Council Urban Design Report

Comments due by:	2 APRIL 2021	Processing Planner:	Mark Batchelor - CKL
Consent number:	SP/0179/20		
Address:	1881 CAMBRIDGE ROAD, CAMBRIDGE		
Applicant:	3Ms of Cambridge Limited Partnership		
Agent:	Abbie Fowler – Mitchell Daysh		
Allocated to:	Matt Riley – Barker & Associates		
Date of site visit:	February 2021

1. PURPOSE OF THIS REPORT

Figure 34 from the AEE, reproduced below, usefully shows the Appendix S19 Structure Plan (below left) against the 3Ms ‘Integration Plan’ (below right).

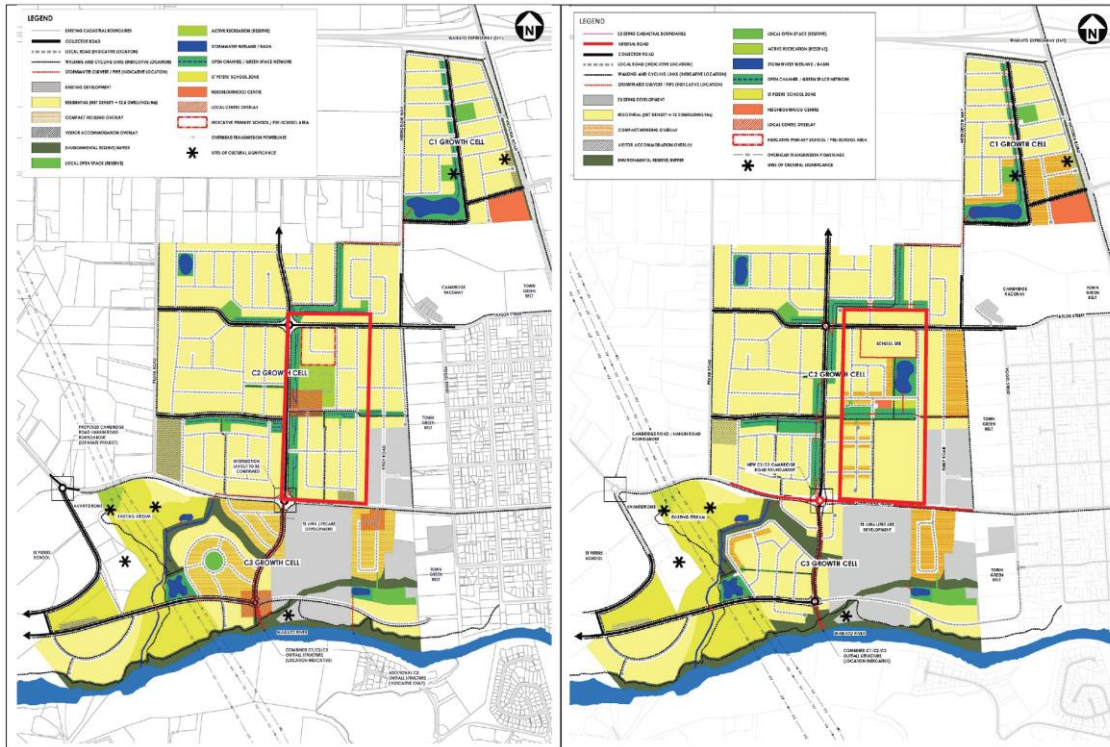
- The north-south collector road and the adjoining north-south stormwater reserve are not on the 3Ms site;
- The active recreation reserve is significantly smaller and is moved away from the north-south collector road further east into the site;
- The school and Neighbourhood Centre are moved away from the north-south collector road further east into the site; and
- The 3Ms application proposes Lots intended for future Compact housing, whereas the Structure Plan shows no Compact housing or other intensified residential lots within that part of the Plan which applies to the site.

- Move the north-south collector road away from the application site, further to the west;
- Retain the north-south stormwater reserve but also move it further west away from the application site; and
- Change the alignment of the north-south collector reserve from being fully on the east side of the collector road, to switching to the west side of the collector road for the southern two-thirds of its length.

- The 3Ms application differs from the Structure Plan in that the Local Centre and the active recreation reserve are moved to the east, away from the collector road, with the active recreation reserve being much smaller in size than the reserve shown on the Structure Plan. Additionally (although I am unclear for what reason, given it is outside the 3Ms' application site) the north-south stormwater reserve is shown on the applicant's Integration Plans to switch halfway along its length to the western side of the north-south collector road. Furthermore, the east-west aligned stormwater reserve, as it enters the site, is not adjoined by a road. In my view, these differences result in a potential wider Growth Cell urban structure (dependent, in part, on how adjoining land owners develop their sites) that does not have the clear street and block visual hierarchy as shown in the Structure Plan.

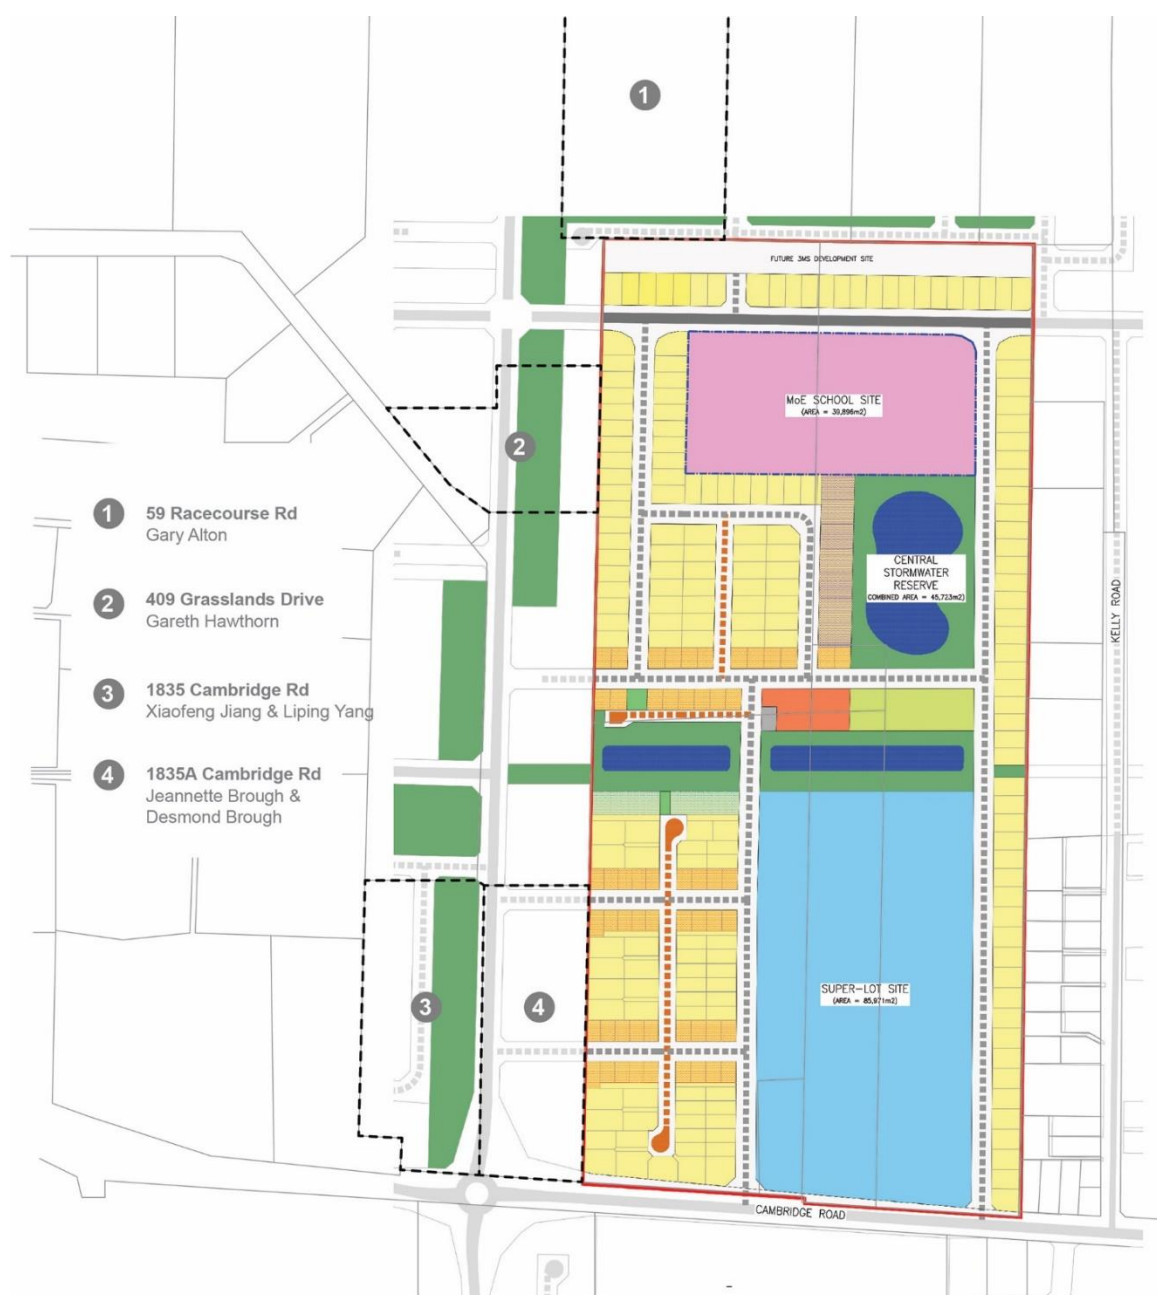
The 3Ms proposal to move the collector road and stormwater reserve to the west outside its land will require co-ordination between a number of different landowners in order to achieve delivery of this infrastructure. Those land owners may not be intending to develop their land in the short to medium term and this will not help with the orderly and efficient development of the C2 Growth Cell.

The 3Ms proposal to move the collector road and stormwater reserve to the west outside its land will require infrastructure to be delivered by a number of different landowners. This will lead to a lack of certainty about the timing or co-ordination of delivery of these infrastructure services.

The 3Ms proposal is not in accordance with the C2/C3 Structure Plan as it moves the north-south collector road and stormwater reserve from the 3Ms land to land to the west.

The 3Ms proposal will result in adverse amenity effects on the urban block structure of the wider C2 Growth Cell. Reasons for this include (but are not limited to): reduced connectivity through the introduction of cul-de-sacs and the east-west stormwater reserves to the west of the application site, which limits north-south connectivity; the resulting block structure imposed upon land to the west of the 3Ms site is not optimised for development in terms of dimension or orientation (for sun or relative to roads and public reserves); and overall the combination of these matters, together with the land ownership pattern, severely undermines the ability to achieve the stated outcomes of the Structure Plan to the west of the 3Ms site.

Uncertainty about the land requirements resulting from 3Ms' proposed repositioning of the north-south collector road and stormwater reserve will affect the Brough's development aspirations and will result in most or all of their land being required for infrastructure at an unspecified time.

Appendix 1: Testing of conceptual subdivision layout on land adjoining application site to the west

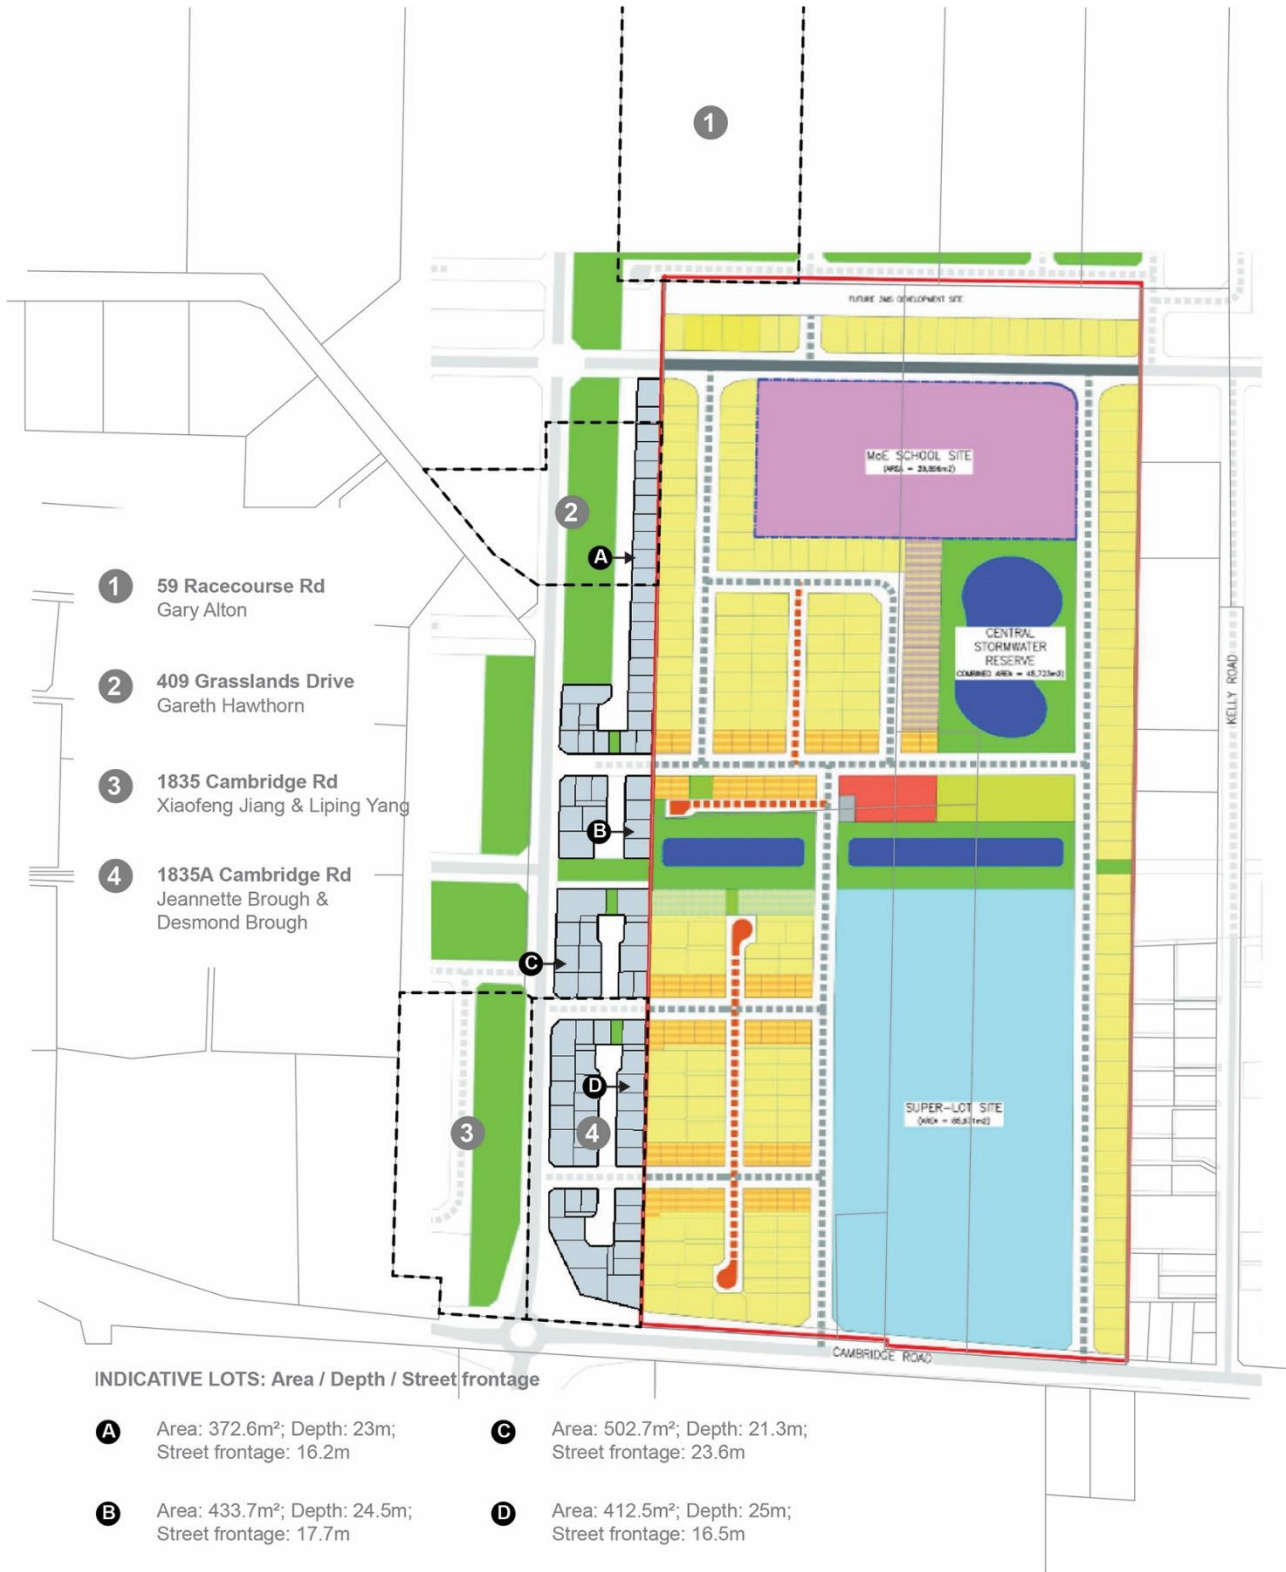
- In a s92 request (question 34), I raised this matter with the applicant team and requested they provide indicative layout options for this land to demonstrate how the 3Ms proposed layout would enable the adjoining land to the west to develop in an appropriate manner. This information has not been provided by the applicant. I have therefore undertaken my own testing, which is attached at Appendix 1. This testing is indicative only, and not intended to represent an ideal layout, or one that has been assessed for ultimate consentability.

- The testing sought to avoid rear lots, long JOALs, and single lot depth blocks. It shows that, in my view, a lot layout that achieves acceptable urban design outcomes is achievable within the spatial constraints set by the north-south collector road to the west, the 3Ms site to the east, and including the 3Ms suggested repositioning and re-alignment of stormwater reserves outside of their site. While I have not undertaken rigorous option testing, it appears to me that these constraints do quite significantly reduce the overall flexibility and range of development options open to land owners to the west.

- I furthermore note that the concept shown at Appendix 1 is not ideal in an urban design sense, with compromises being necessary to achieve a rational layout. The concept has extensive use of cul-de-sacs - although the heads of all but one of the cul-de-sacs is opened up with a walking and cycling link, achieving good permeability and connectivity. Additionally width constraints mean that fitting in a north-south access road for these land parcels in addition to lots with road (rather than JOAL frontages) means that lots are of a generally smaller size, averaging from the high 300m² range to the low 400m² range.²⁶
